Questions for PCSD RFP_2019_001

Switch Rack Layout

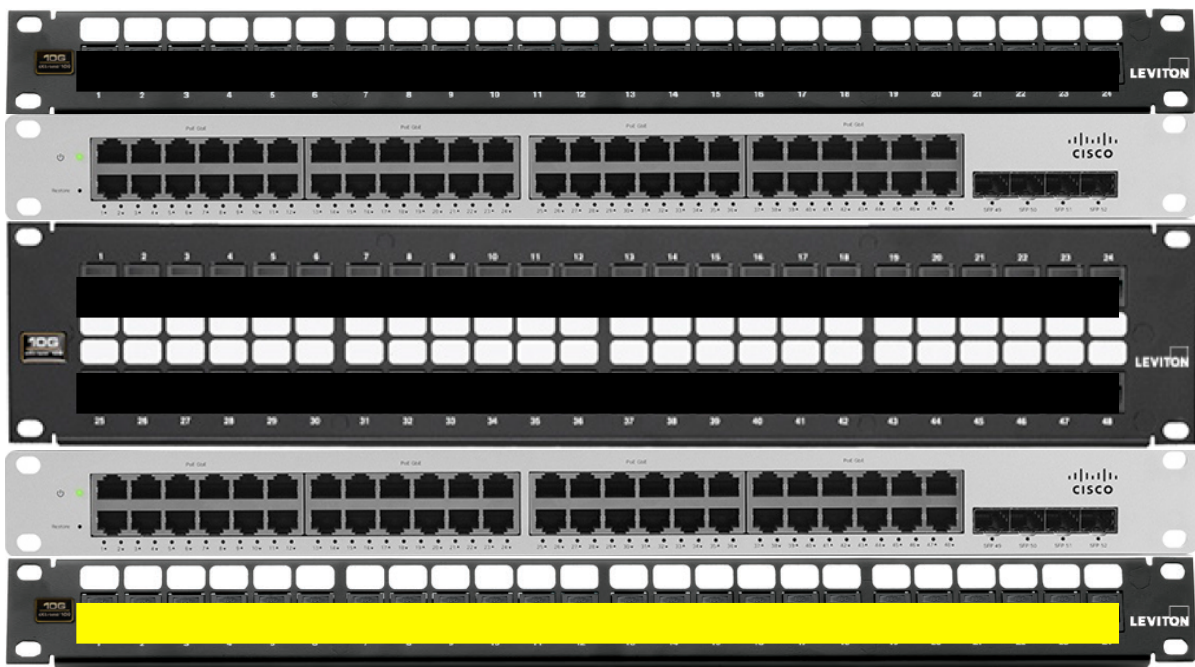
1. Are Vendors responsible for re-terminating and testing new and existing cable as part of the closet cleanup?

During the walk through I stated that only new cable will need to be identified. However, after reviewing the RFP and the expectation of PCSD all cabling will need to be re-terminated and tested during the closet cleanup. This will require new patch panels for all cabling. PCSD is expecting switches and cabling to be mounted in the racks a certain fashion including color coded patch cables in order to simplify ongoing support of infrastructure. In order to do this it will require moving existing cabling and adding new cabling in a uniform fashion. See Switch Rack Layout Example
